## CATHOLIC CENTRAL CONNECTOR ROAD JSP21-17

Consideration at the request of Catholic Central High School for Planning Commission's approval of Preliminary Site Plan, Wetland Permit, Woodland Permit and Stormwater Management Plan. The subject property is zoned R-4 One Family Residential, R-1 One Family Residential, and I-1 Light Industrial and is located in Section 18, west of Wixom Road and south of Twelve Mile Road. The applicant is proposing to construct a new driveway to provide a connection from the existing loop road to Twelve Mile Road through the northern area of the property. Utilities, stormwater detention and wetland mitigation are also proposed.

**PLAN REVIEW CENTER REPORT**  
**Planning Review**  
**CATHOLIC CENTRAL CONNECTOR ROAD**  
 JSP 21-17  
 November 17, 2021

**WETLAND AND BUFFER IMPACTS**  
 CATHOLIC CENTRAL HIGH SCHOOL CONNECTOR ROAD & UTILITY PLAN  
 SECTION 18, CITY OF NOVI, MICHIGAN

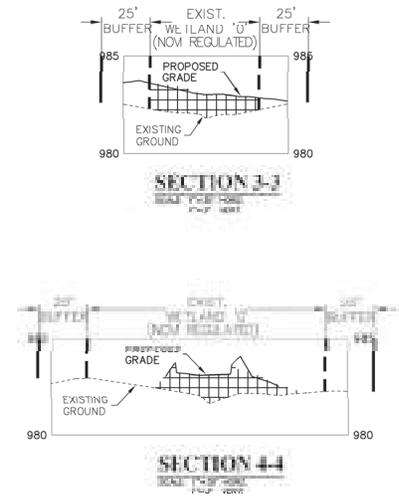
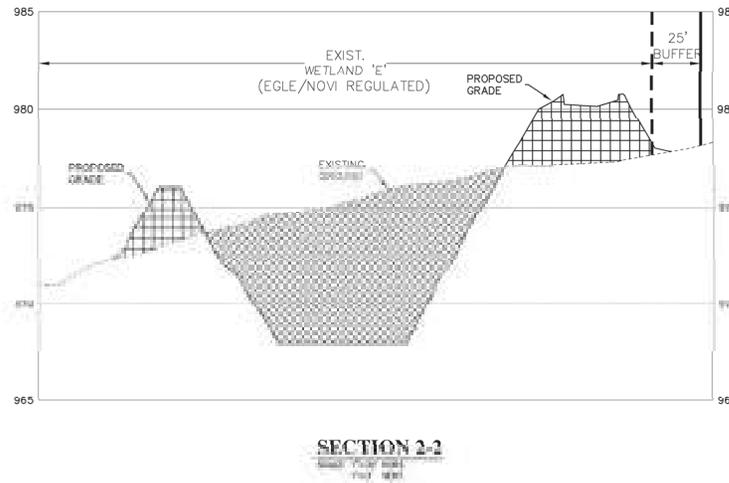
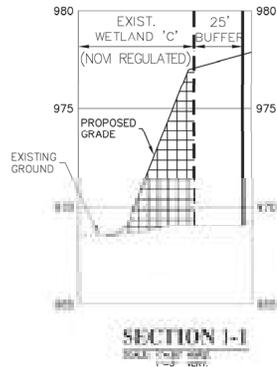
MSG approximated the relative location of the proposed connector road on the City and EGLE maps, and compared the City wetland map to Sheet CE-12. It appears the areas shown as Wetlands A and E in the rrPSP approximately correspond to City-regulated wetland areas. Sheet CE-12 portrays impact to City-regulated Wetland E, the buffer of Wetland A, and impacts to wetlands and buffers that are not identified on the City of Novi Wetlands Maps. Sheet CE-12 also specifies 0.84 acre of wetland mitigation area is anticipated to be required.

Sheet CE-12 depicts construction of an on-Site 0.925-acre wetland mitigation area adjacent to Wetland E. Since the primary objective of the mitigation wetland is to replace forested wetland lost from Wetland E, the constructed wetland should be designed to result in forested wetland habitat.

MSG notes the planting plan on Drawing L-02 (of the PSP) specifies a minimum of 10 individuals of a minimum of four species of tree are to be planted, with a total quantity of 72. Further, the performance standards on Drawing L-03 require a minimum of 300 trees per acre of at least three species at the end of the monitoring period. These and other specifications should be adjusted as necessary to meet the requirements of the EGLE permit after it is obtained.

These comments still apply. MSG notes the on-Site wetland mitigation area has been adjusted from 0.925-acre to 0.84-acre. Also, the planting plan (Drawing WML-2 of the rrPSP) identifies a total quantity of 350 trees in the forested mitigation area.
